# Validation Report

## Maduru Oya Left Bank Main Canal at 24+140 Drop 9 Mini- hydro Power Project

Report No: SLCCS/VDR/2023/01

Version : 02

**Figure 1 : Location Map**  
Source: Survey Department

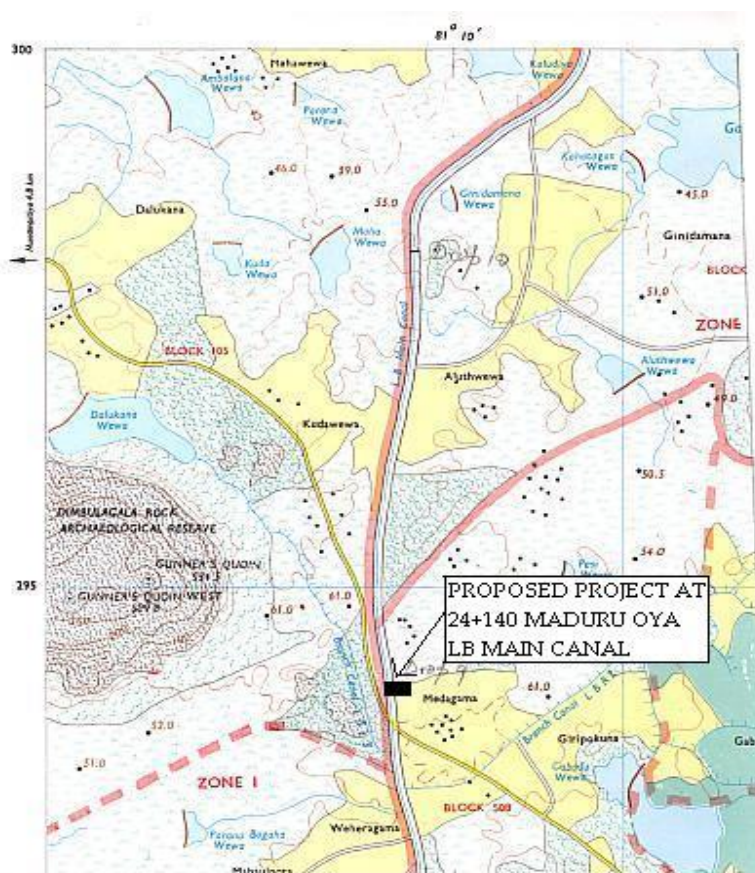
<b>Type of the Finding</b>	<input type="checkbox"/> CL <input checked="" type="checkbox"/> CAR <input type="checkbox"/> FAR
<b>Finding No</b>	CAR-4
<b>Ref. To CMA</b>	Section 1.5 & 5.3
<b>Action requests by validation team</b>	<p>a. The location map provided in section 1.5 is not relevant to the project activity described in the document</p> <p>b. Emission sources included and excluded from the project activity are not clearly documented and justified in the section 5.3 of CMA version 01</p>
<b>Summary of Project owner response</b>	<p>a) The location map displayed in section 1.5 was mistakenly included in the document. This error has been rectified, and the correct site map has been provided instead.</p> <p>b) The table indicating the reporting boundary of the project activity was expanded with justification for inclusion and exclusions of emission sources.</p>

<b>Validation team Assessment</b>	<p>The location map provided in revised CMA was verified to be correct and appropriate during the validation assessment. The map is developed based on the 1:50000 map published by the Survey Department</p> <p>Complying with <i>AMS-1.D "Grid connected renewable electricity generation" Version 18.0</i>, a table has been included to justify the inclusions and exclusions of baseline and project level emissions. The emission resulting from the operation of on-site back-up generator was identified as a project emission and included in the section of project emissions. The major emission source attributable to this process is CO<sub>2</sub> which was added in the table with a justification.</p>
<b>Conclusion</b>	<p><input type="checkbox"/> To be checked during the first periodic verification</p> <p><input type="checkbox"/> Additional action should be taken (finding remains open)</p> <p><input type="checkbox"/> Project documentation was corrected correspondingly</p> <p><input checked="" type="checkbox"/> <b>Appropriate action was taken. The finding CAR-4 is closed</b></p>

Figure 2: Project boundary of Maduru Oya Left Bank Main Canal Drop at 24+140 hydropower plant

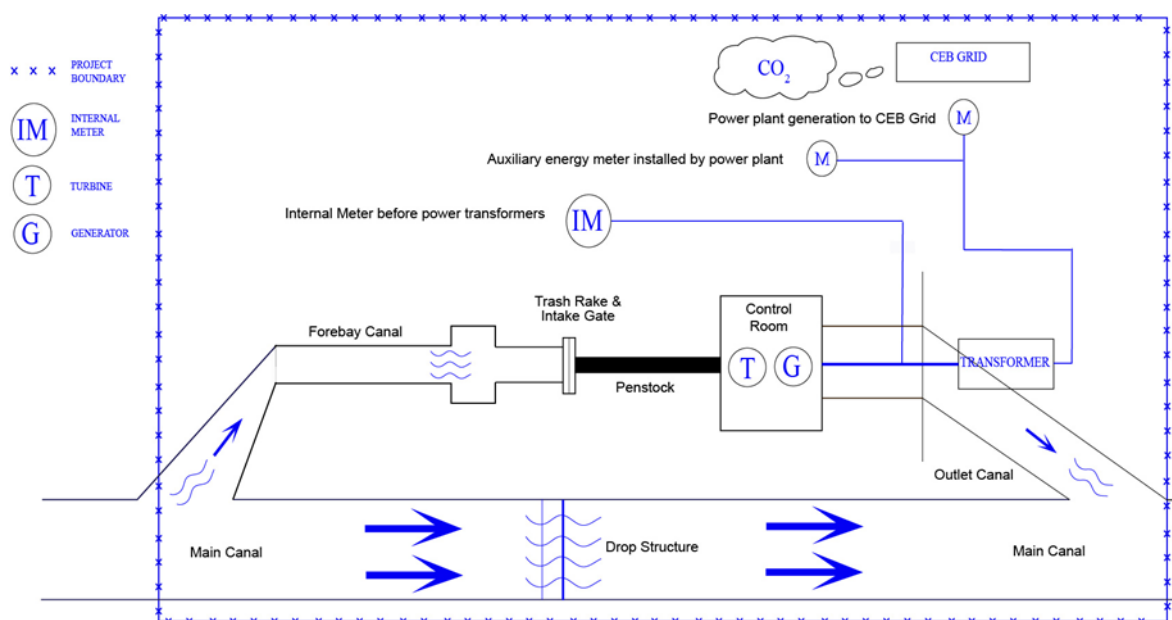
<b>Type of the Finding</b>	<input type="checkbox"/> CL <input checked="" type="checkbox"/> CAR <input type="checkbox"/> FAR
<b>Finding No</b>	CAR-5
<b>Ref. To CMA</b>	Section 7.3
<b>Action requests by validation team</b>	<p>a. A clear diagram is not available to show the project boundary of the project activity.</p> <p>b. Organization Structure (OS) given in section 7.3 is not compliant with the evidence documents gathered during the validation assessment. The diagram should be redrawn to address the latest changes in the organization structure</p>
<b>Summary of Project owner response</b>	<p>a. A diagram illustrating the key components of power plant; main canal, forebay canal, power house, transformer, control room, main CEB energy meters, Auxiliary energy meter was included in the revised CMA to show the boundary of the project activity.</p> <p>b. Organization structure was revised including the key positions responsible for the safe operation of power plant, Civil Engineer- maintenance, Electrical engineer and assistant operators.</p>

<b>Validation team Assessment</b>	<p>a. The diagram illustrating the project boundary of the project activity was verified to be in order during the post validation assessment. Further it was confirmed that diagram is clear enough to address the requirements of paragraph 18 given in <i>AMS-1.D "Grid connected renewable electricity generation" Version 18.0</i></p> <p>b. Validation team reviewed revised organization structure in revised CMA and confirmed the full compliance with the latest changes of the administration system. Additionally, the roles and responsibilities of positions effectively contributing to the operation of power plant were verified during the validation assessment</p>
<b>Conclusion</b>	<p><input type="checkbox"/> To be checked during the first periodic verification</p> <p><input type="checkbox"/> Additional action should be taken (finding remains open)</p> <p><input type="checkbox"/> Project documentation was corrected correspondingly</p> <p><input checked="" type="checkbox"/> <b>Appropriate action was taken. The finding CAR-5 is closed</b></p>
